SUNDRY NOTICES AND REPORTS ON WELLS
Do not use this form for proposals to drill or to re-enter an
abandoned well. Use form 3160-3 (APD) for such proposals.

Revised Drilling Plan
High Lonesome 23 Federal No. 1
 Cimarex Energy Co. of Colorado
 23-16S-29E
 SHL 2310 FNL & 660 FEL
 BHL 2310 FNL & 330 FWL
 Eddy County, NM

Revised Drilling Plan

Location: Eddy County, NM
Field: (Lonesome 23) Sec 23, T16S, R29E
Facility: High Lonesome 23 Fed Com No. 1H

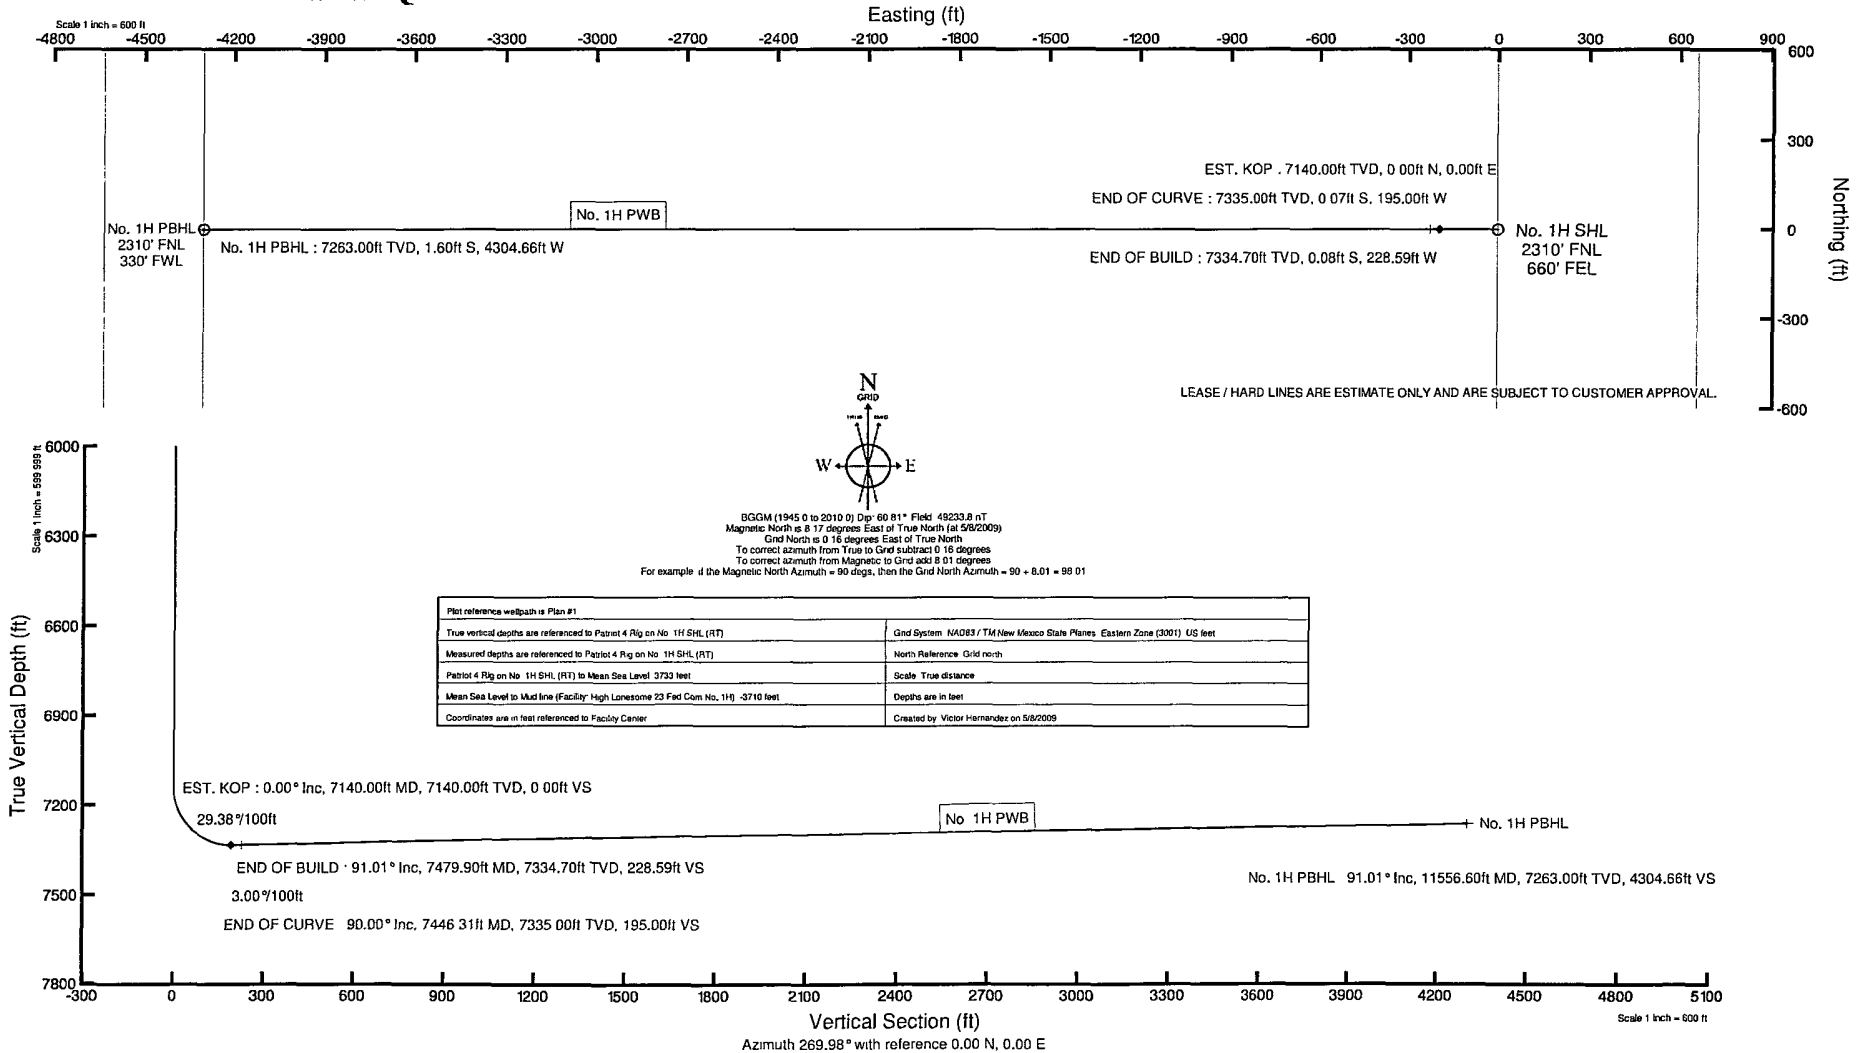
Also, our preliminary drilling plan, including KOP, EOC, and TD, has changed. Revised preliminary directional survey attached.

Design Comment	MD (ft)	Inc (°)	Az (°)	TVD (ft)	Local N (ft)	Local E (ft)	DLS (°/100ft)	VS (ft)
TIE ON	0.00	0.000	269.979	0.00	0.00	0.00	0.00	0.00
EST. KOP	7140.00	0.000	269.979	7140.00	0.00	0.00	0.00	0.00
END OF CURVE	7446.31	90.000	269.979	7335.00	-0.07	-195.00	29.38	195.00
END OF BUILD	7479.90	91.008	269.979	7334.70	-0.08	-228.59	3.00	228.59
No. 1H PBHL	11556.60	91.008	269.979	7263.00	-1.60	-4304.66	0.00	4304.66
